### Invitation to Tender No. 2023-PRC-06 Arts and Heritage Hub ADDENDUM #9

## **Addendum #9: Invitation to Tender (ITT) No. 2023-PRC-06**

# Tender Addendum TA009

### TA009 – General Questions – Arts & Heritage Hub

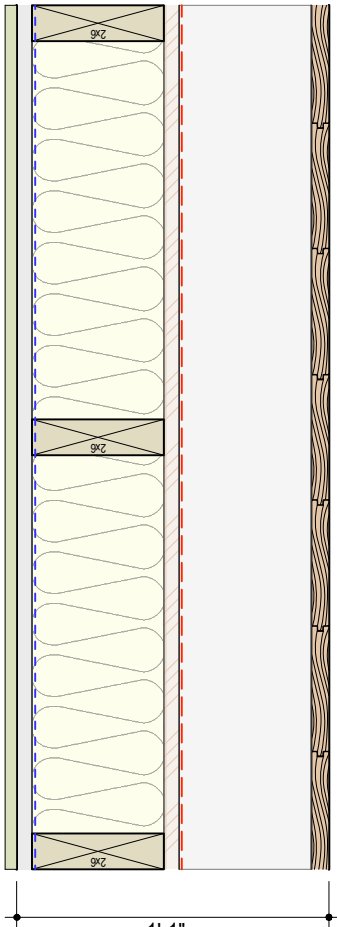
6. Can we get more clarification on Wall assembly XW01? It says 5 1/2" Z-Girts. Is this correct?

7. What gauge of metal is to be used for these Z-Girts?

**Please use 5-1/2" galvanized ventilated Z-Girts from Monarch Metal Inc.**

**18 Ga. (.051").**

- XW04 Wood Louvers**
- FR* -- *BCEC --*  
*R*(*in*) --
- 2" x 12" cedar slat, stained @ 18" o.c.
  - 1" stabilization rod as per structural drawings

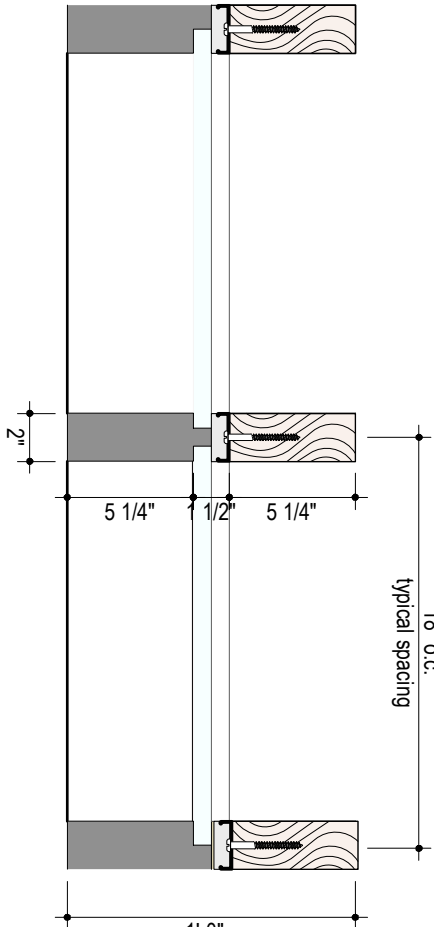
10. Structural Steel - A031 - XW 94 Wood Louvres show a 1" stabilization rod. Please specify rod type

**Please see question 20 from TA006**

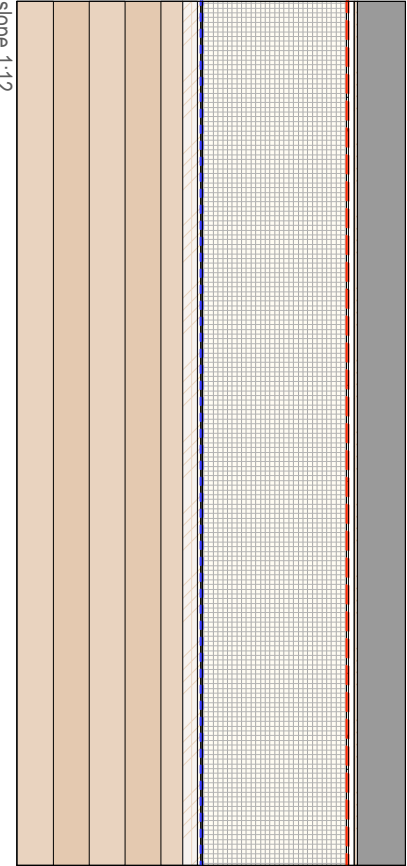
9. The metal roof spec calls for a 15-year RCABC warranty

- a. Warranty not available for a project with a roof slope less than 2/12
- b. RCABC also requires a 5/8" plywood sheathing for any warranty.
- c. This project has 1/2" plywood sheathing.

Specification section 07 61 00 Sheet Metal roofing indicates that a 15 year RCABC warranty is required. This warranty is not attainable due to the following:

- The roof slope must be 2:12 or greater to obtain a 15 year warranty
- Under a 4:12 roof slope requires a mesh underlayment and EPDM pads under clips, and a 3mm underlay
- Prolock 12 is a snap panel and only mechanical seam can be utilized under (2:12)

22. The specification calls for a 15-year RCABC warranty for the metal roof, however the roof slope is 1/12 and we understand that RCABC warranty is not available for roofs with a slope of less than 2/12. RCABC also states a minimum structural deck thickness of 5/8", however the structural deck shown is 1/2". Please provide further clarification.

**Please see attached revised roof assembly RW01. This assembly should be able to obtain a 10 year RCABC.**

- RW01 GUT - Standing Seam Roof**
- FR* 14.099  
*R*(*in*) 14.099
- Mechanical lock seam with 2" height • 30x1 lip in seam.
  - Rubber pads below dips
  - Extruded Mesh (cedar sheath)
  - Stormy attic duct (base sheet)
  - 6" polyc
  - Non permeable vapour barrier
  - 3x4" 1x6 D FR plywood sheathing\*
  - 5" ply filled GUT\* - Finished see specs.
